***VIRGINIA DEPARTMENT OF ENVIRONMENTAL QUALITY***

Re: Mountain Valley Pipeline, LLC (MVP)  
Erosion & Sediment Control (ESC) Plan Modification (2) Approvals

The Department of Environmental Quality (DEQ) hereby approves the following modifications to the Erosion & Sediment Control (ESC) Plan:

- MLV-23 and MVP-MLV-AR-23, Sheets 12.07ES and 12.08ES, Sign/Seal dated 8/14/2023, Sheet 12.08PC, Sign/Seal dated 12/7/2022.
- MLV29, H602/H-603 Tap Sites, Details 33.1-33.4, Sheet 14.34ES, Sign/Seal dated 3/30/2022, Sheets 15.78 ES, 15.91ES, Sign/Seal dated 5/5/2022 Sheets 15.92ES, 15.93ES, 14.34AES, Sign/Seal dated 8/14/2023.

DRAWN BY:	JUZ
CHECKED BY:	IHH
APPROVED BY:	DCW
DATE:	07/31/2023
SCALE:	AS SHOWN
SHT. NO. 12.08ES OF 12.34ES	REVISION

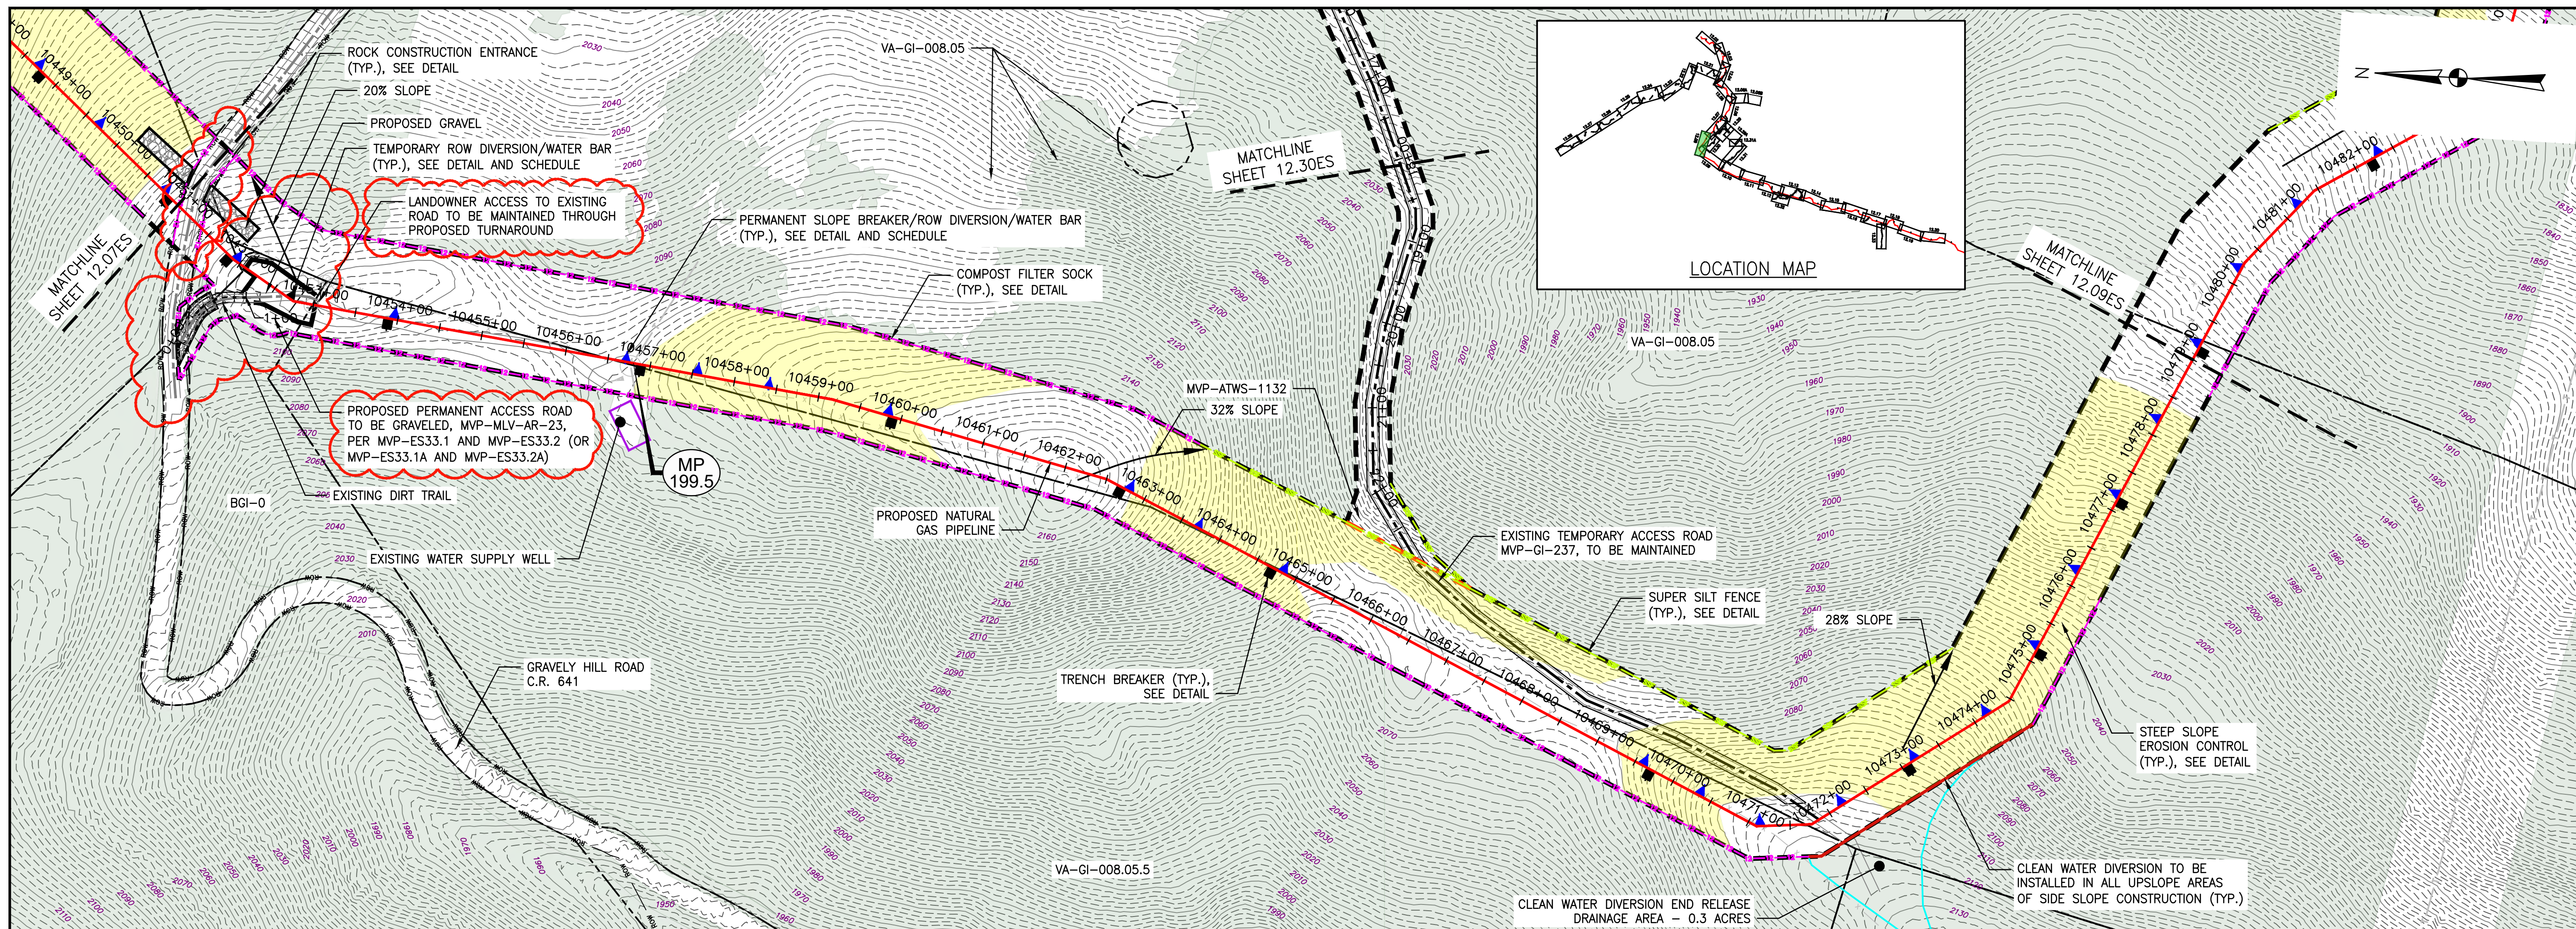
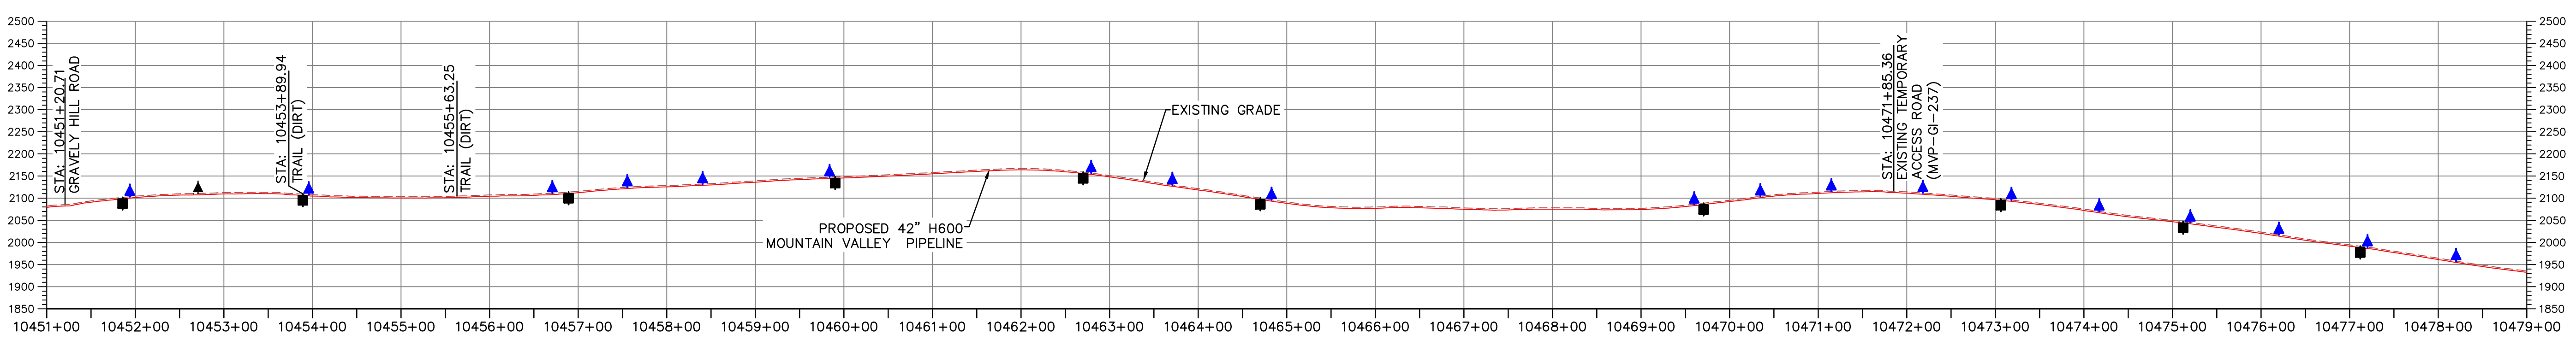
NO.	DATE	BY	DESCRIPTION
1	07/31/23	JUZ	UPDATE BAFFLE SPACING FOR RELOCATION OF MLV-23
2	12/07/22	MJP	FILE MODIFICATION - MP 199.5 (MP-23 SITE AND ACCESS ROAD MVP-MLV-AR-23)
3	01/29/19	JWK	ADDRESS VADQC COMMENTS
4	03/16/18	KAL	ADDRESS VADQC COMMENTS
5	02/26/18	KAL	ADDRESS VADQC COMMENTS
6	02/22/18	KAL	ADDRESS VADQC COMMENTS

DRAWN BY:	JUZ
CHECKED BY:	IHH
APPROVED BY:	DCW
DATE:	07/28/2023
SCALE:	AS SHOWN
SHT. NO. 14.34ES OF	14.81ES

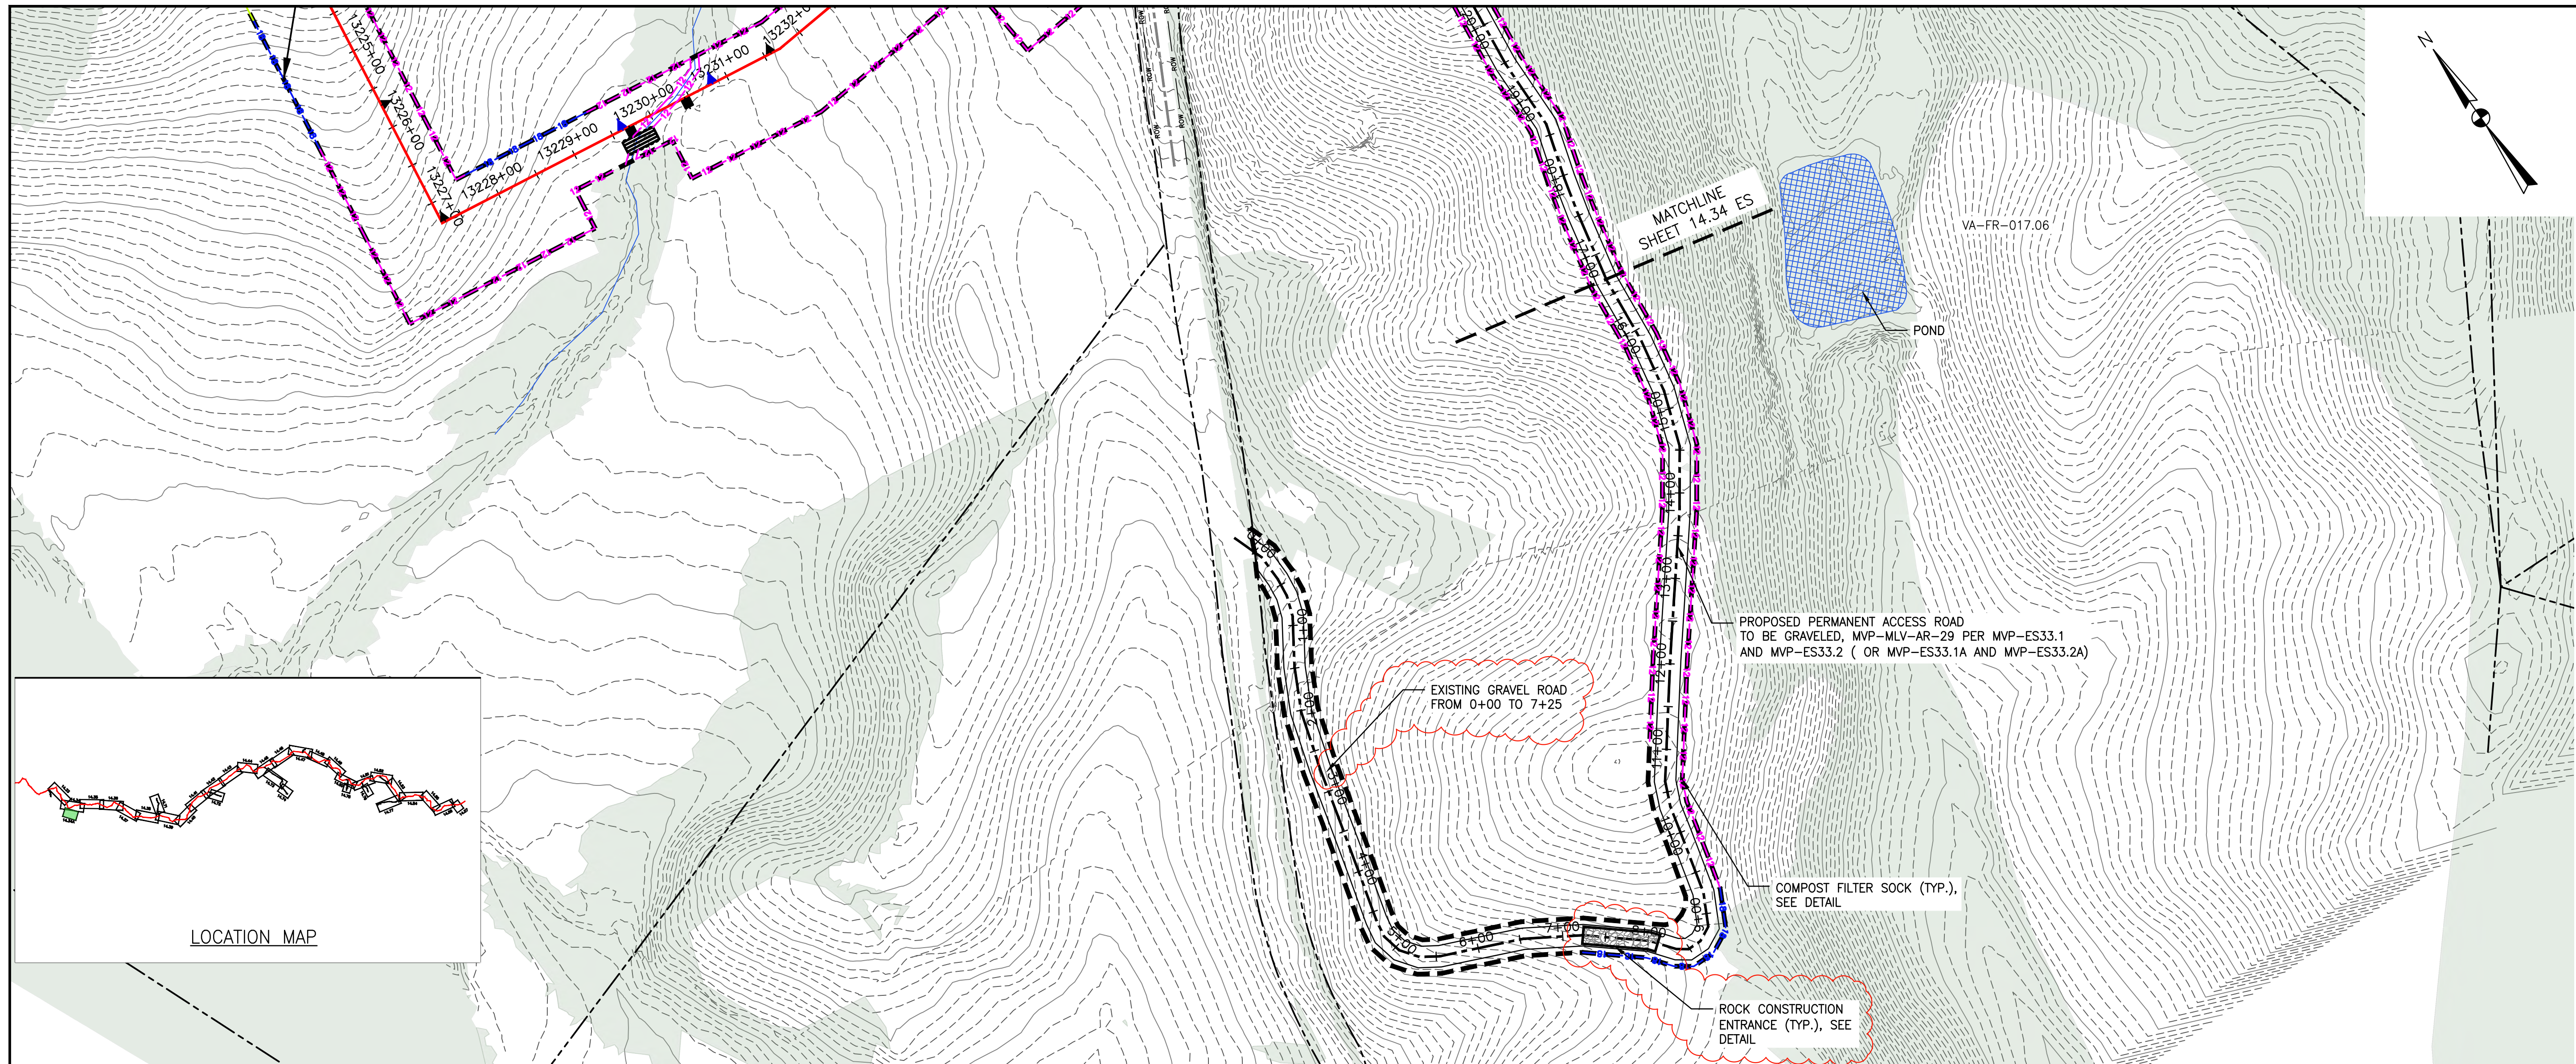
NO.	DATE	DWN.	CHKD.	APPD.	DESCRIPTION
-	07/28/23	JUZ	IHH	DCW	ADDRESS DED COMMENTS
-	05/30/22	JUZ	RE	TD	ADDRESS VADEQ COMMENTS TO FIELD MODIFICATION SUBMITAL
-	06/04/21	JUZ	RE	DW	FIELD MODIFICATION - MV-29 RELOCATED TO APPROX. MP 252.1

DRAWN BY:	JUZ
CHECKED BY:	RE
APPROVED BY:	TD
DATE:	03/30/2022
SCALE:	AS SHOWN
SHT. NO. 14.34ES	OF 14.81ES

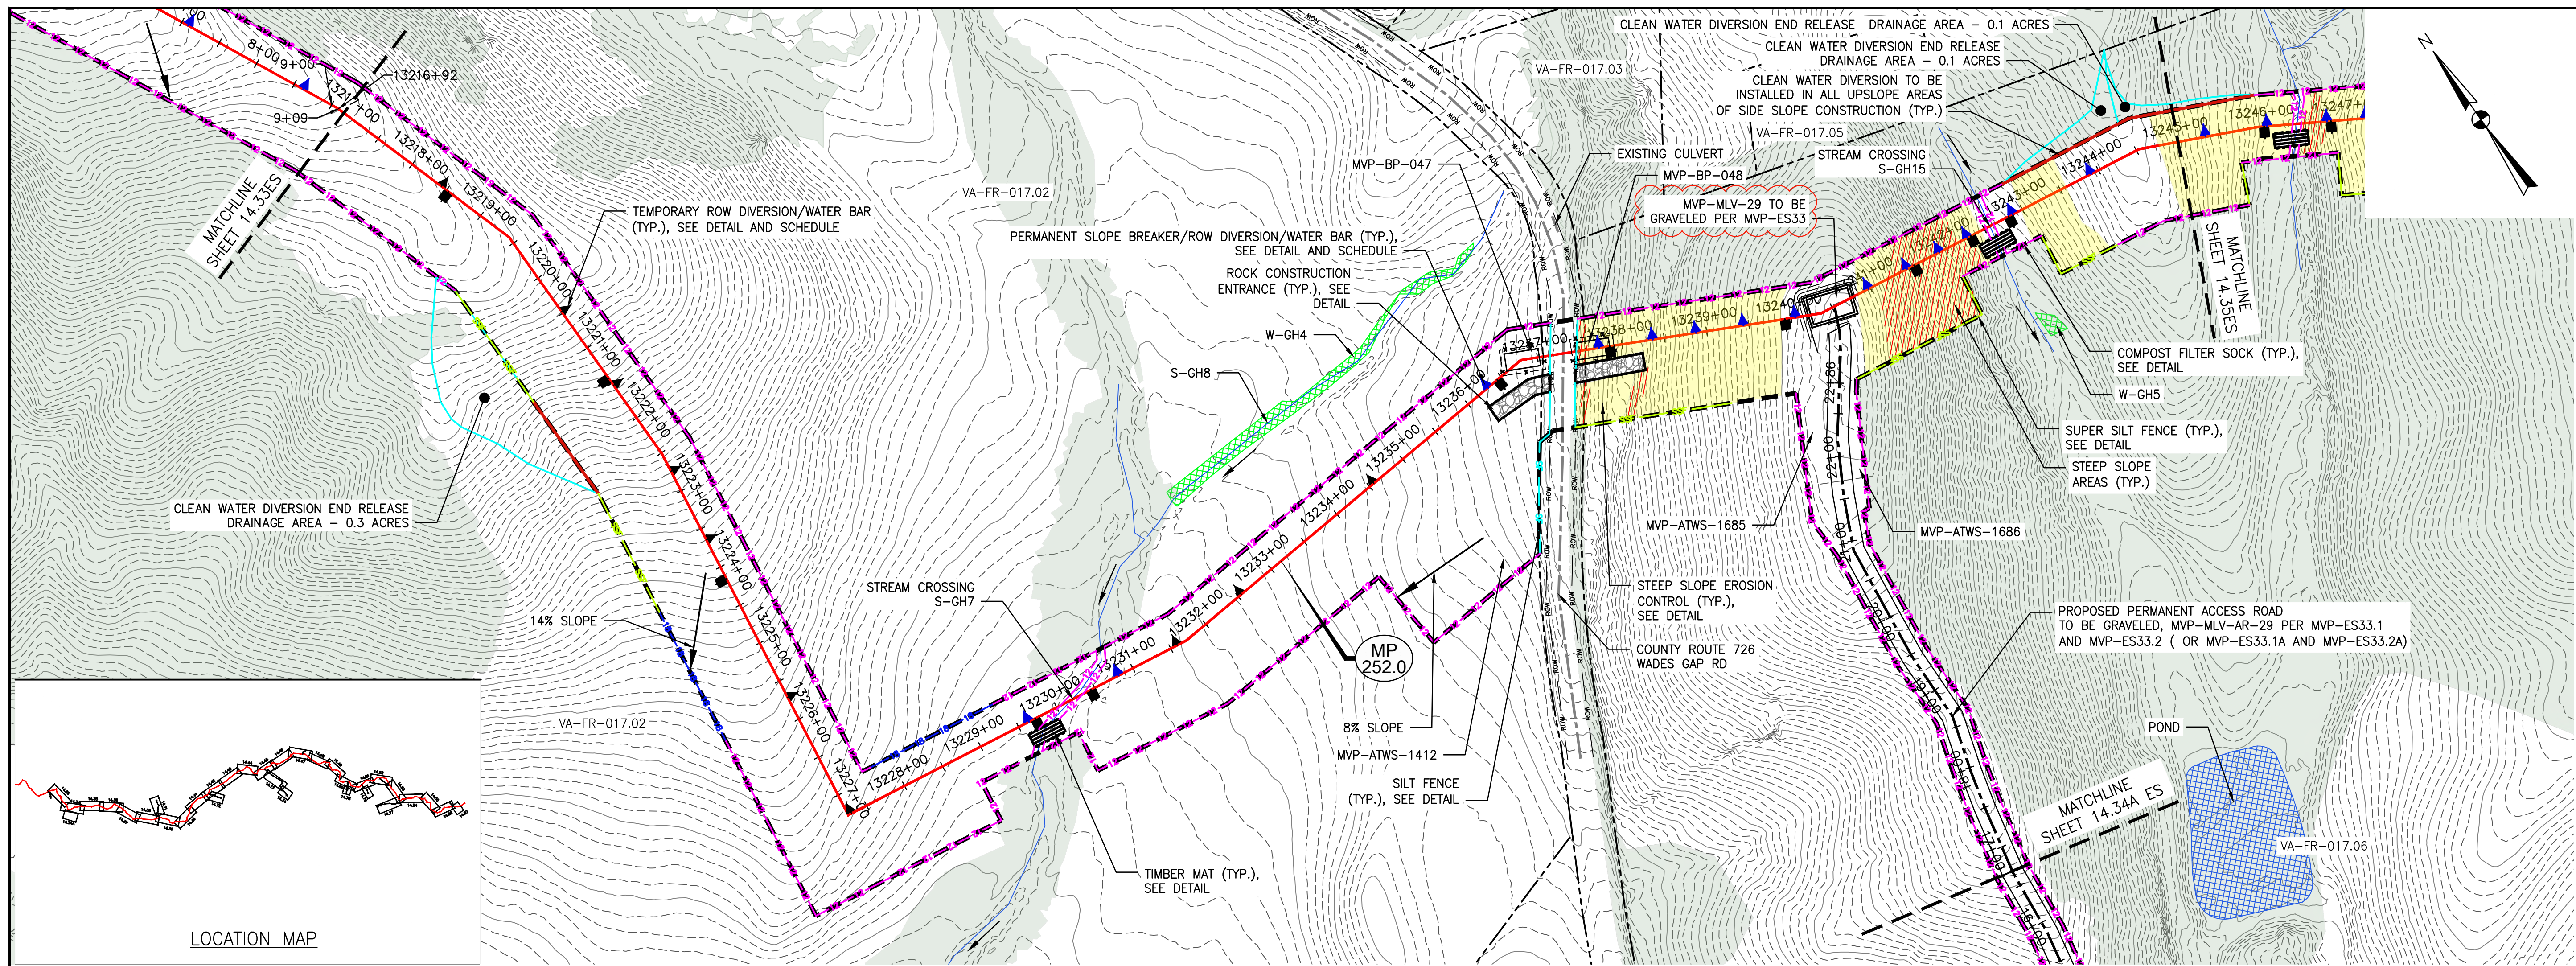
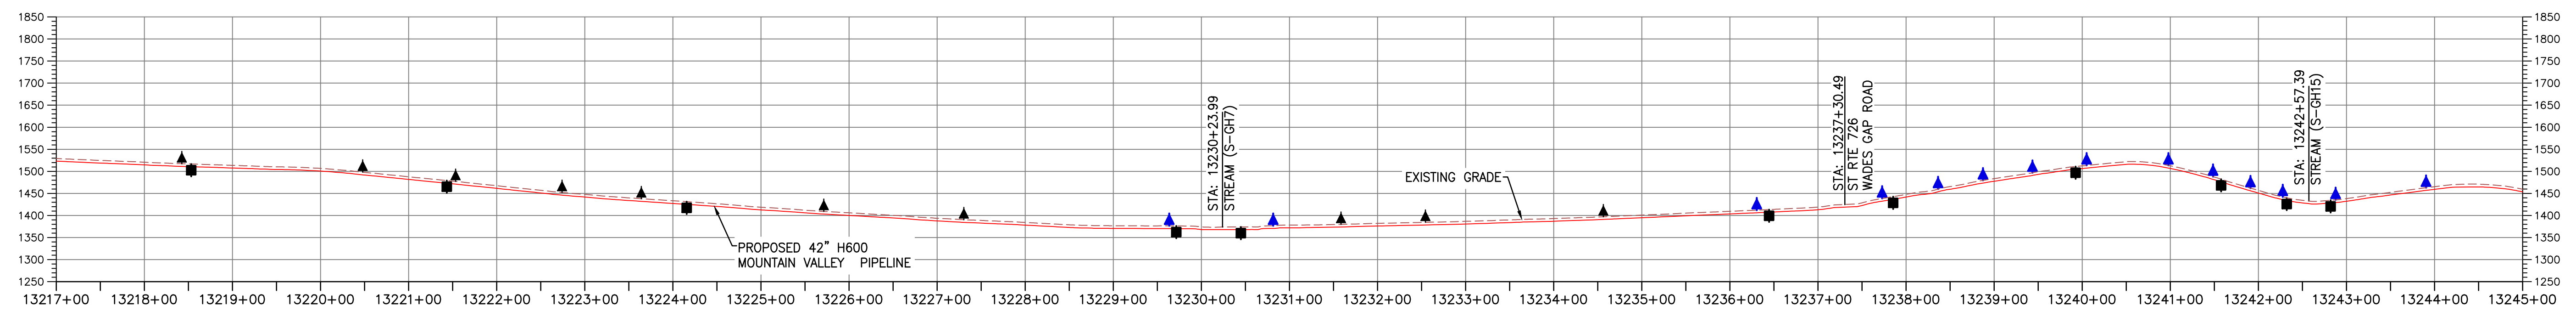
NO.	DATE	CHKD.	APPD.	DESCRIPTION
1	03/30/22	JUZ	RE	FIELD MODIFICATION - MVP-29 RECORDED TO APPROX. MP 252.1
2	06/04/21	JUZ	RE	ADDRESS VADO COMMENTS
3	03/04/18	KAL	RE	ADDRESS VADO COMMENTS
4	02/27/18	KAL	RE	ADDRESS VADO COMMENTS
5	02/05/18	KAL	RE	ADDRESS VADO COMMENTS
6	11/21/17	KAL	RE	ADDRESS VADO COMMENTS
